No. EL/3.1.35.17 Dated: As signed

MODIFICATION SHEET NO. RDSO/2024/EL/MS/0500 (Rev. '0')

Recording of Flasher Light operation either due to fault or manually by Loco Pilot in case of emergency with time stamping in VCU of 3-phase electric locomotives.

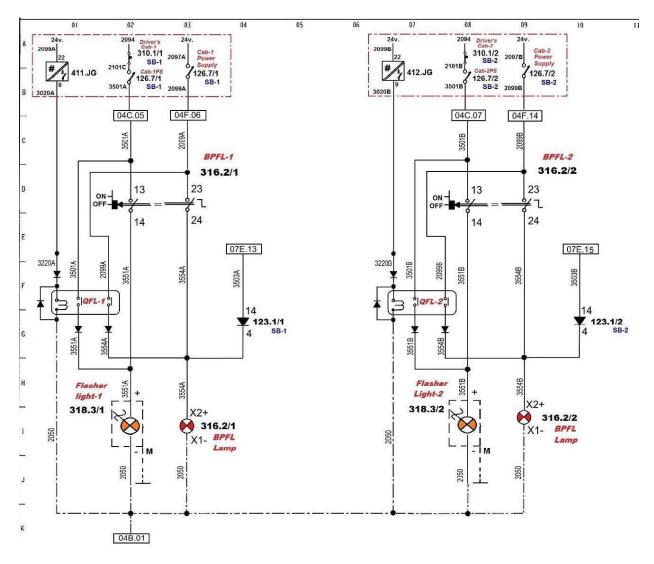
At present, signal of automatic flasher light operation is available on MVB and recorded n VCU. However, manual operation of flasher light through BPFL switch by loco pilot is not getting monitored by VCU. Therefore, there is requirement for monitoring the operation of flasher light either due to fault or manually by Loco Pilot in case of emergency with time stamping in 3-phase electric locomotives.

Signal of Alarm Chain Pulling is available on MVB which reflects the operation of Auto Flasher Light. However, manual operation of flasher light by BPFL switch (316.2) is not monitored by VCU. The existing schematic are shown below:

Since, Machine Room Blowers (MRBs) and scavenge to MRBs (ScMRBs) are being shifted from single phase supply to Auxiliary Converters' three phase supply in IGBT based three phase electric freight locomotives as per RDSO's Modification Sheet No. RDSO/2020/EL/MS/0482, Rev '1' during implementation of energy saving scheme. After the aforesaid modification, 2 nos. input channels i.e. 411. OA10 and 412. OA10 have become free. Out of these 2 nos. free input channels, 01 number (411. OA10) has been utilized for monitoring of flasher light operation either due to fault or manually by Loco Pilot in case of emergency in proposed modified scheme. The proposed modified scheme has been attached as Annexure-1 for implementation of the same.

- (i) Software modification to delete previously mapped capacitor message on 411. OA10.
- (ii) Software modification to read input channel 411. OA10 for operation of flasher light.
- (iii) Software modification in data recorder file to record operation of flasher light with time stamping for continuous recording of signal.
